## Corporation of the Township of Brock

### Staff Report to the Mayor and Members of Council

**From:** Wayne Ward  
**Position:** Manager Parks, Recreation, Facilities & IT  
**Title / Subject:** King Street Park  
**Date of Report:** January 31, 2024  
**Date of Meeting:** February 8, 2023  
**Report No:** 2024-PRF-001

Image 1: 300m Track and Half-Pitch Soccer Field

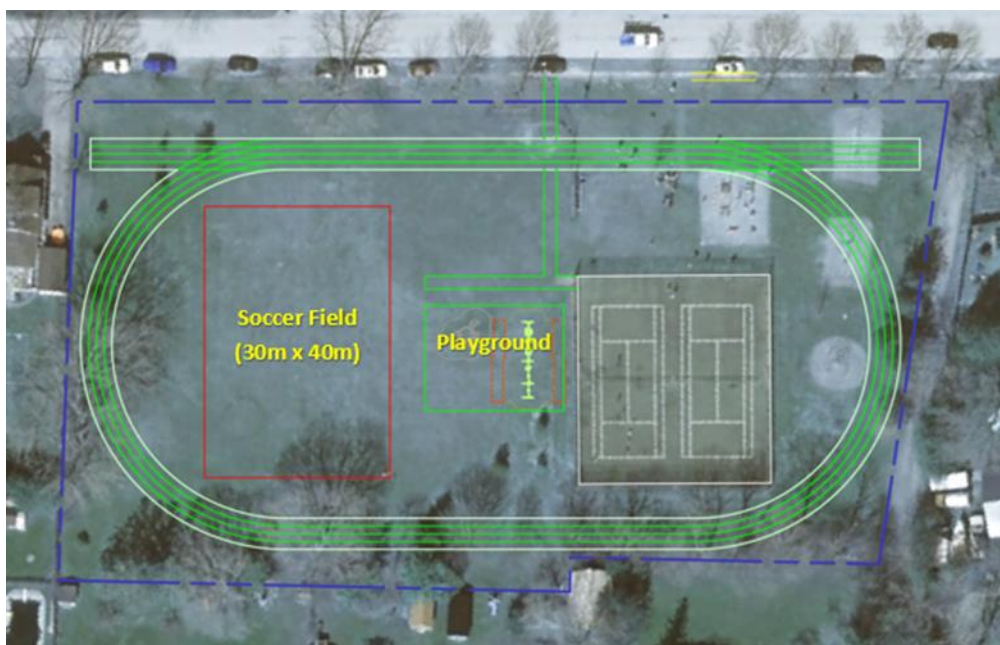
It has been noted by Envision Tatham that the proposed 300m track (Image 1) would encompass the entire outer portion of the property and would not allow for the typical buffer of 15m between residential properties and recreational amenities. Additionally, the removal of several mature trees abutting the residential properties would need to be undertaken.

The playground would need to be located inside the track. This could be unsafe for families trying to access the playground, particularly during heavy use period of the track.

Envision Tatham also noted that a 300m track is not a typical length track. Outdoor tracks of similar nature are usually 400m in length while indoor tracks are 200m in length. These numbers allow for easier distance counting with even numbers. Further, the original track located on the school grounds at Beaverton Public School was a length of 200m.

Envision Tatham indicated as an alternative a 200m track (Image 2) which would allow for less impact to the property and adjoining properties with the exception of the 100m sprint track which will still extend completely across the frontage of the property. This configuration allows for more green space outside of the track area which could be used for replacement play structures and any future uses.
